WEST HAVEN PLANNING COMMISSION AGENDA

August 12, 2026 6:00 P.M.

PRELIMINARY SITE PLAN REVIEW

Request: Grant preliminary site plan for the Weber County Fire Station
Property Location: 2625 West 3600 South
Property Zone: A-1, Agricultural
Property Size: 2.2 acres
Applicant: John McLaughlin, AJC Architects

Image 2: Proposed Site Plan (topside north)

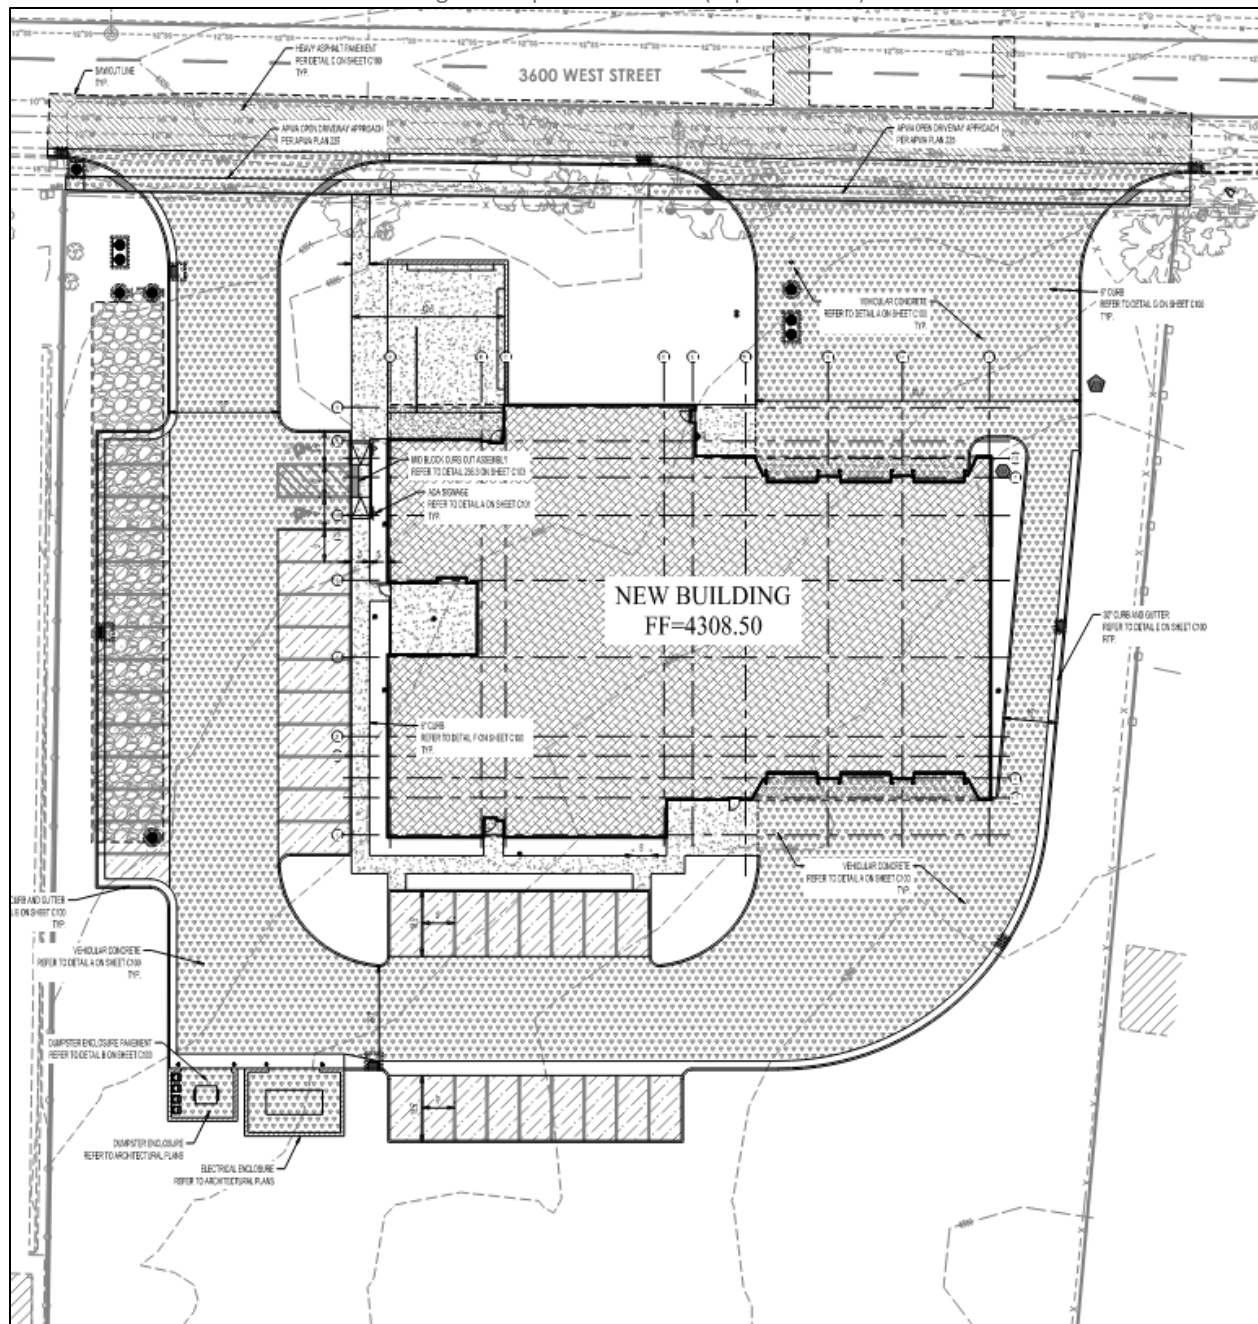
Code Reference	City Department	City Comment	Applicant Response
§157.236	Planning	Will-serve letters are needed from the following utility providers: Culinary water, secondary water, and sanitary sewer.	
§157.635(D)(1)	Planning	Each parking space shall be not less than nine feet wide and encompass not less than 180 square feet of net area.	
§32.09(D)(1)	Engineering	See the attached redlined drawings for all comments and corrections related to Engineering and Public Works standards.	
§157.734(A)(6)	Planning	Call out the upgraded architectural features for each façade, including the percentage of coverage for each façade. A minimum of 15% of the front elevation shall consist of upgraded architectural features as defined in division (C). Non-primary elevations that do not face the street or major corridor shall consist of at least 5% upgraded architectural features.	
§157.634	Planning	The Planning Commission may adjust the required number of spaces listed in this

subchapter if, based on accepted engineering principles, unusual or unique circumstances or conditions relating to the operational characteristics of the use exist in a manner, or to such a degree, that such adjustment is equitable and warranted. Provide a letter from a traffic engineer that supports a parking reduction, and the commission may adjust the minimum requirement as requested.	
§157.988(B)(1)(c)	Planning	Turf area shall not exceed 15% of the total landscaped area. Specify the Grass Seed Mix as turf or otherwise. If the seeded area is turf, then adjust the area size accordingly.	
IBC	Building	There shall be a complete geotechnical study completed on the site. The number of borings shall be determined by the geotechnical engineer. A copy of the report shall be provided to the city once completed.	
IBC	Building	Provide the slope of accessible parking areas and access aisles. The slope shall not exceed 2% in all directions at any point.

IBC	Building	Provide the running slope and cross-slope for all accessible sidewalks. Cross slope shall not exceed 2%.	
IBC	Building	Provide elevation detail for accessible parking signage.

§32.09(D)(1)	Planning	Fire District approval has been received and annotated.	
-------------------------	----------	---	--

Image 2: Proposed Site Plan

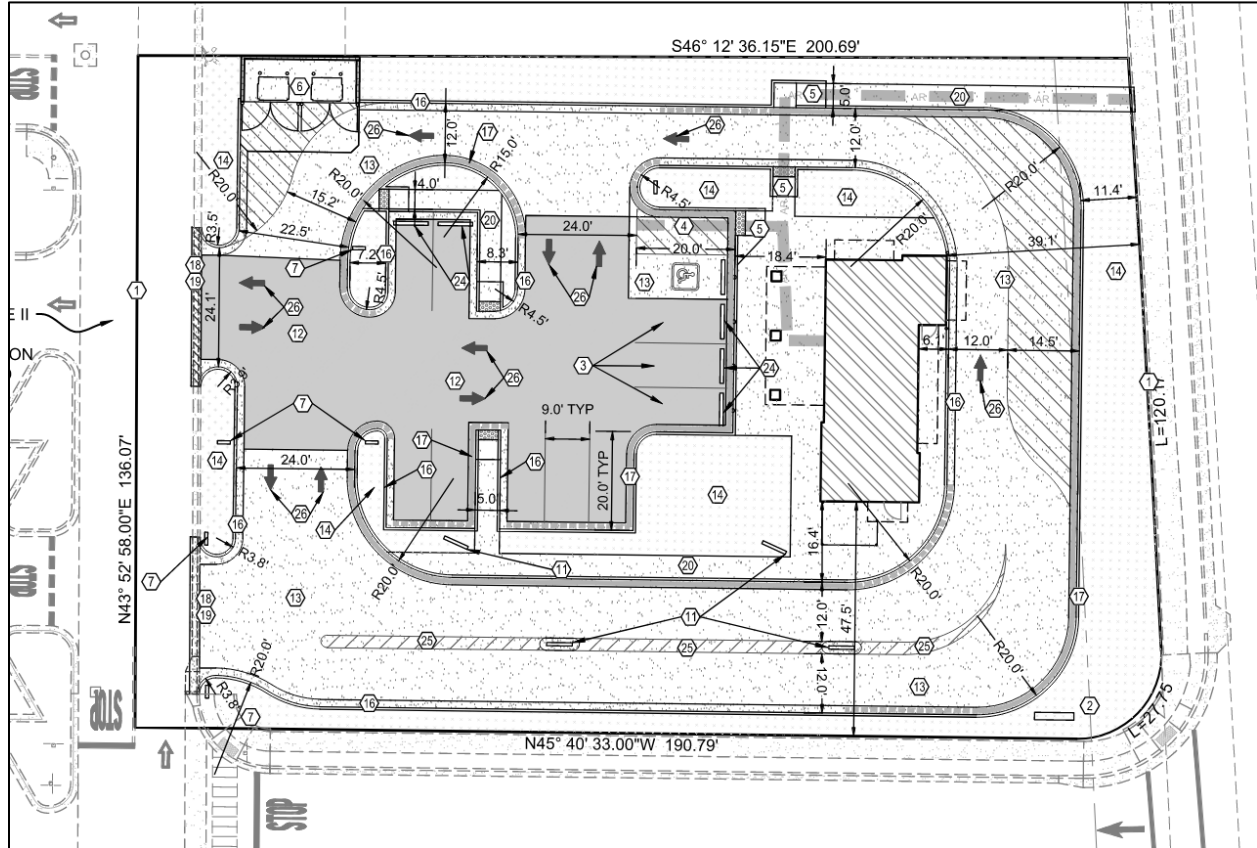
Finding: The proposed wall signs are compliant with the city sign ordinance. However, a monument sign is proposed, depicted on the site plan in the southeast corner of the site. Under normal circumstances, a monument sign would be permitted for the proposed use in this zone, but the site is part of a planned commercial center. Any freestanding signage will need to comply with the signage plan approved for the host commercial center.

Finding: The proposed landscaping is mostly compliant with the standards of the zoning ordinance, including minimum tree and shrub requirements and plant coverage requirements. The site does, however, lack the required 15' of landscaping along the entire frontage at Midland Drive. The applicant has been made aware of this deficiency through the attached corrections report.

Additionally, the proposed landscape plan shows no plantings in the adjacent park strip, whereas our code requires street trees. Because the adjacent street is state-owned and operated, City staff is currently working with UDOT staff to determine the landscaping requirements of this area.

- All freestanding signs will comply with the sign package of the planned commercial center in which the site is located.

- All staff comments and corrections on the attached corrections report are satisfactorily addressed prior to final site plan approval.
- The park strip adjacent to the subject property is landscaped as required by local and state regulations.

SITE PLAN

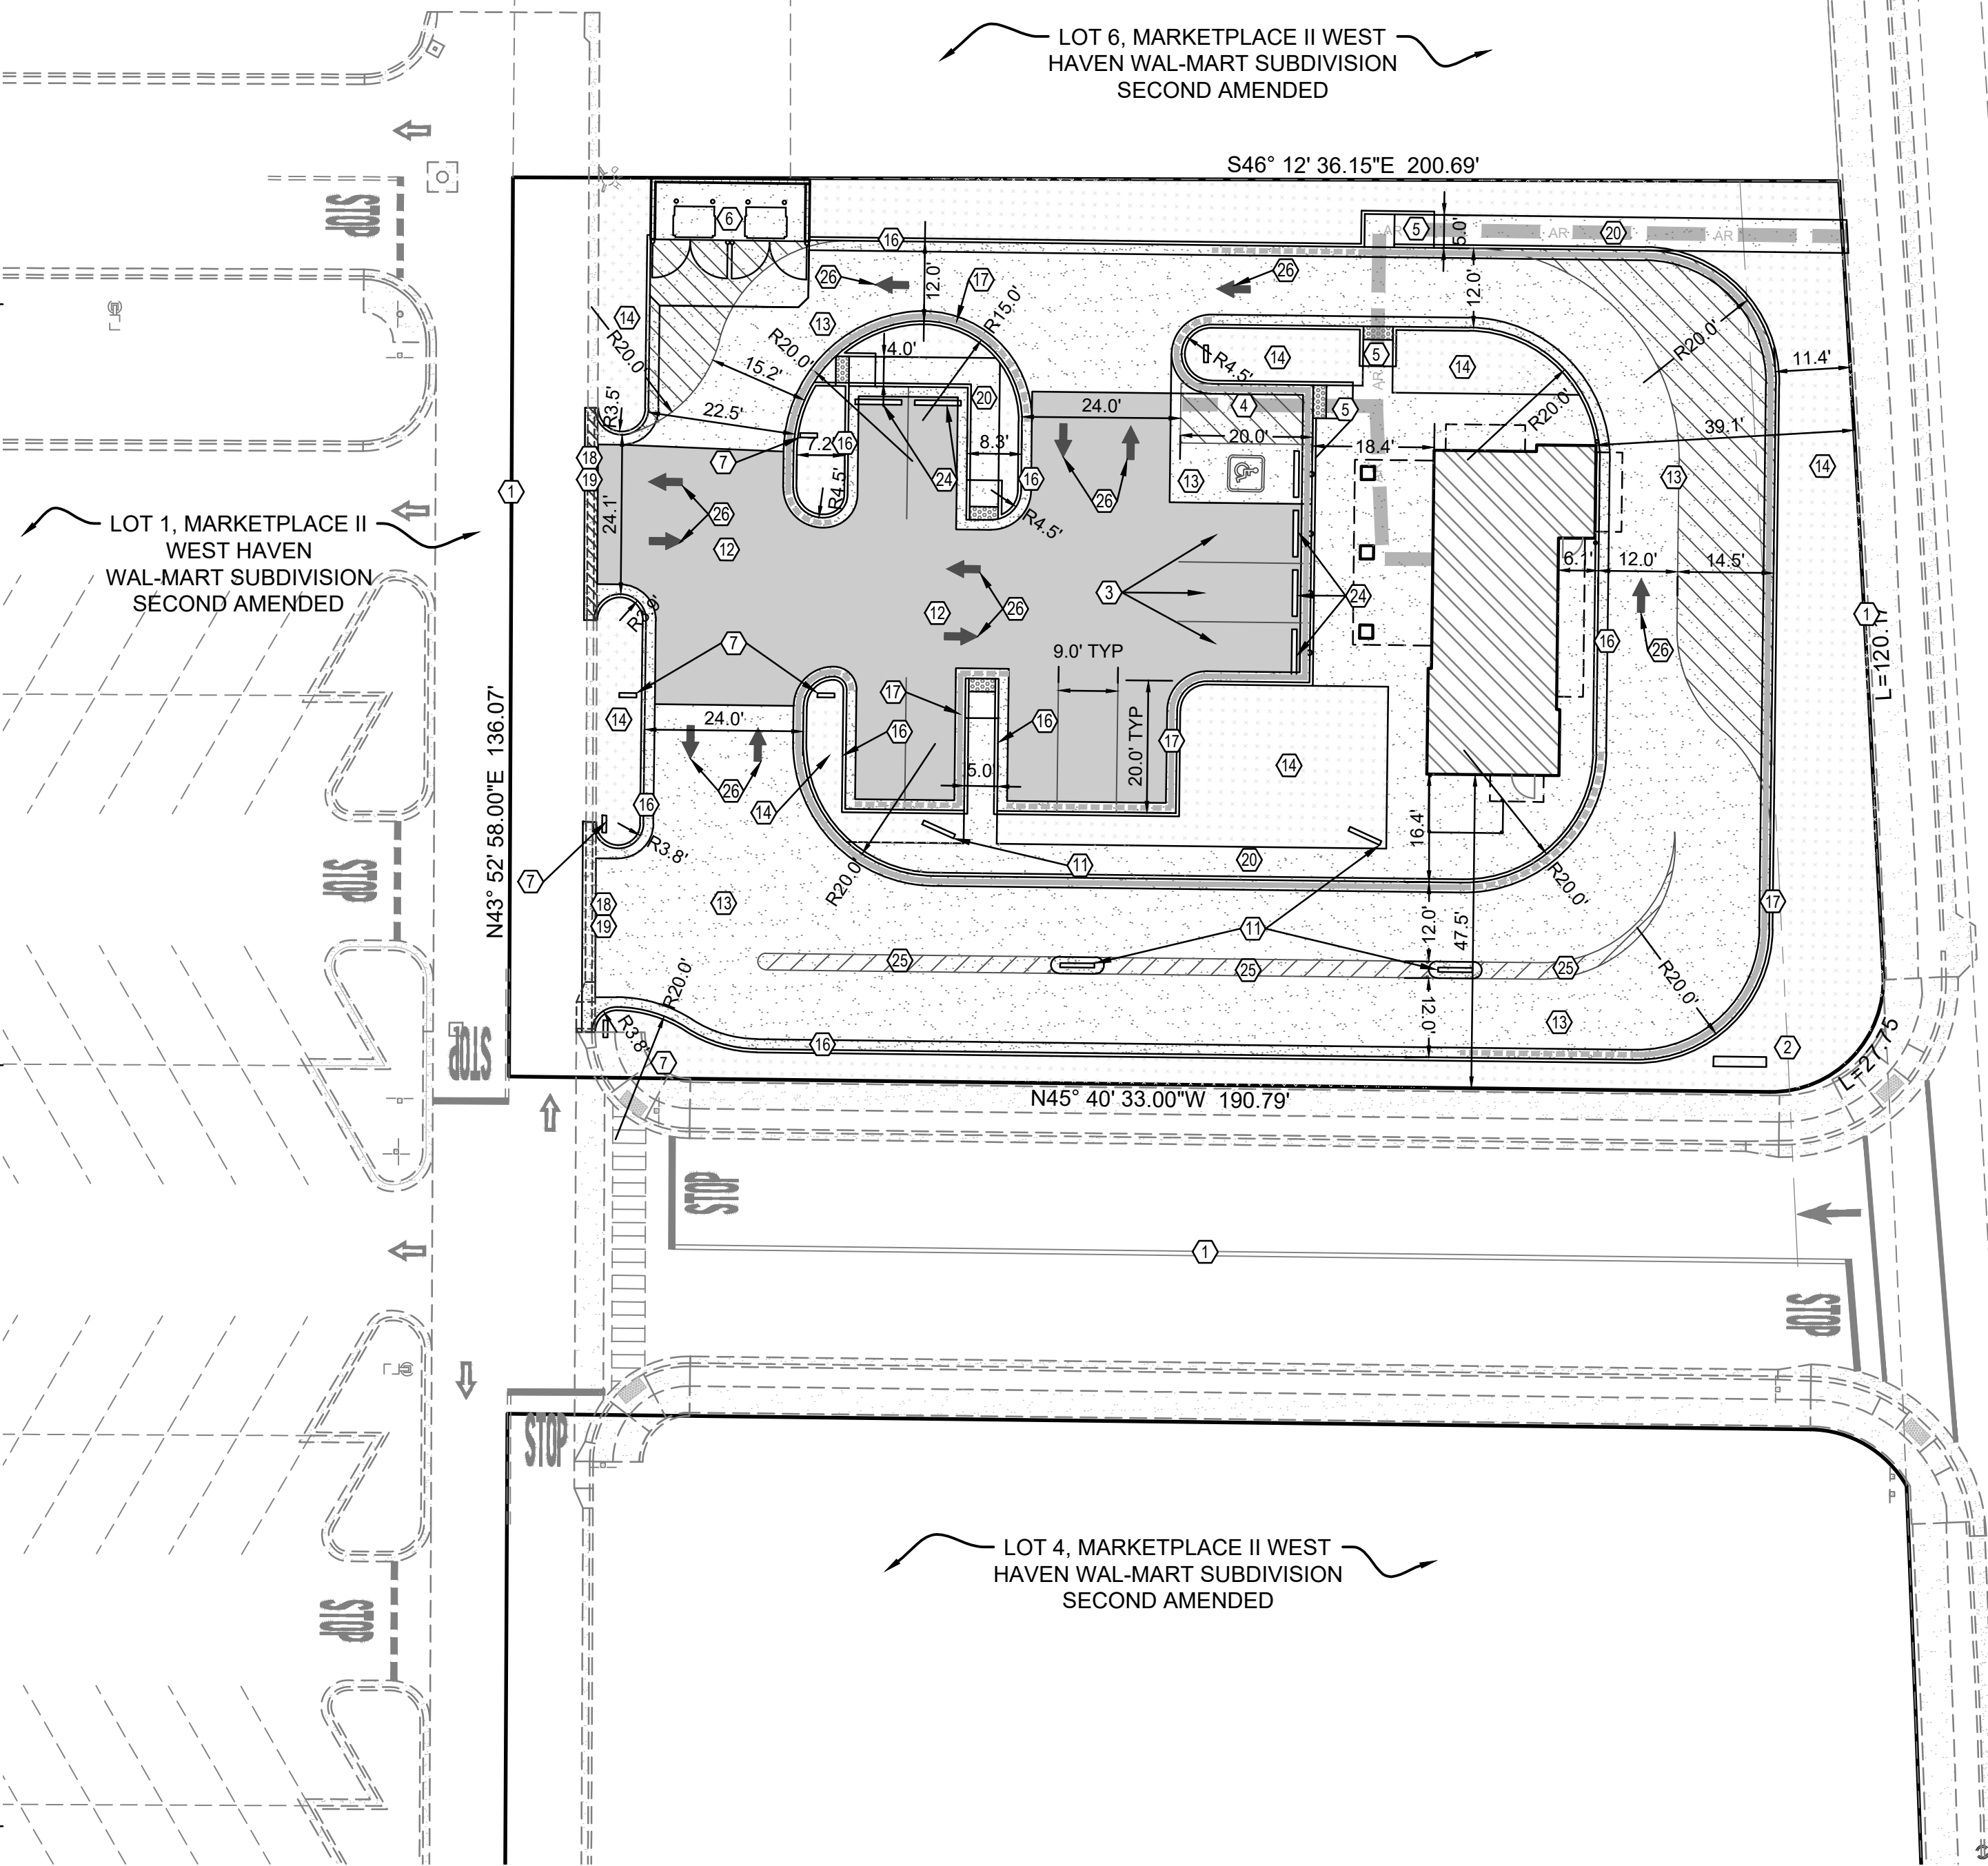
Code Reference	City Department	City Comment	Applicant Response
§157.731(C)(1)(g)	Planning	Provide will-serve or availability letters from the following utility service providers: 1. Culinary water; 2. Secondary water; and 3. Sanitary sewer districts.	
§157.731(C)(1)(c)	Planning	On the building elevations sheet, provide the percentage of area coverage for each finish material per facade. The façade that faces Midland shall be constructed of a minimum of 60% primary materials (defined in §157.734(C)(1)). Note that stucco is classified as a secondary material.	
§157.733(D)(1)(a)	Planning	Landscaping is required along the entire frontage of the lot (adjacent to Midland Drive) at a minimum depth of 15 feet, as measured from the property line shared with the Midland Drive right-of-way.

§157.635(D)(1)	Planning	Each parking stall shall be at least 9' wide and encompass no less than 180 square feet.	
§157.632(B)(2)	Planning	Aisle entrances and directional traffic flow shall be clearly designated by signs and pavement markings. Provide such markings near the south property access, before the drive-through entrance.	
§157.632(B)(6)	Planning	A vehicle path analysis shall be performed by a licensed engineer to show how vehicles of various types will maneuver the drive-through lane;	
§157.632(B)(7)(a)	Planning	The west menu board is too close to the drive-through entrance. 80 feet between the drive-through lane entrance and the menu board	
§157.632(C)(1)	Planning	Provide markings or material change to delineate the pedestrian crossing in the drive-through egress lane on the north side of the property. Pedestrian walkways shall have clear visibility and shall be delineated from the pavement.

§157.731(C)(1)(f)	Planning	Provide a signage plan for review that shows the location, size, and material of all signs. The review of this plan may result in additional comments and corrections.	
§157.759(L)	Planning	Monument signs shall be setback from any adjacent property line one foot for each foot of sign height, including any base or supporting structure.

§157.731(C)(1)(h)	Planning	Provide landscape features around the proposed monument sign. Monument signs shall be incorporated into a landscaped design or planter box	
§157.731(C)(1)(j)	Planning	Because of the project's proximity to a state highway, UDOT will need to approve the proposed site access and layout. Provide correspondence that proves the site plan has been reviewed by UDOT staff.	
§157.733(E)(4)	Planning	Buildings within 100 feet of the centerline of Midland Drive shall be designed so that it appears the front of the building faces Midland Drive.	
§157.734(A)(6)	Planning	A minimum of 15% of the front elevation (facing Midland Drive) shall consist of upgraded architectural features as defined in §157.734(C)(3) . Non-primary elevations that do not face the street shall consist of at least 5% upgraded architectural features. On the building elevations sheet, provide the percentage of area coverage for each upgraded architectural feature per facade.

§157.731(C)(1)(b)	Planning	Provide material details for the dumpster enclosure. All dumpsters that are visible from the adjacent public right(s)-of-ways, parking lots, or access drives shall be fully enclosed with opaque fencing or walls.

§32.09(D)(1)(a)	Planning	The Weber County Fire Marshal's Office shall approve the plan set prior to final site plan approval.	
§157.733(D)(1)(a)	Building	Provide a complete geotechnical study for the site.	
§157.733(D)(1)(b)	Building	The cross slope of the accessible parking area and access aisle cannot exceed 2% at any point. Show the cross slope of the accessible parking area and access aisle.	
§157.733(D)(1)(b)	Building	The slope of the accessible route out of the front of the building is noted as 2.1%. Landings at egress doors shall not exceed 2%. IBC 1010.1.4.	
§157.733(D)(1)(c)	Fire	Please call 801-782-3580 Ext 301 to pay review fee.	
§157.733(F)	Engineering	See the attached redlined drawings.
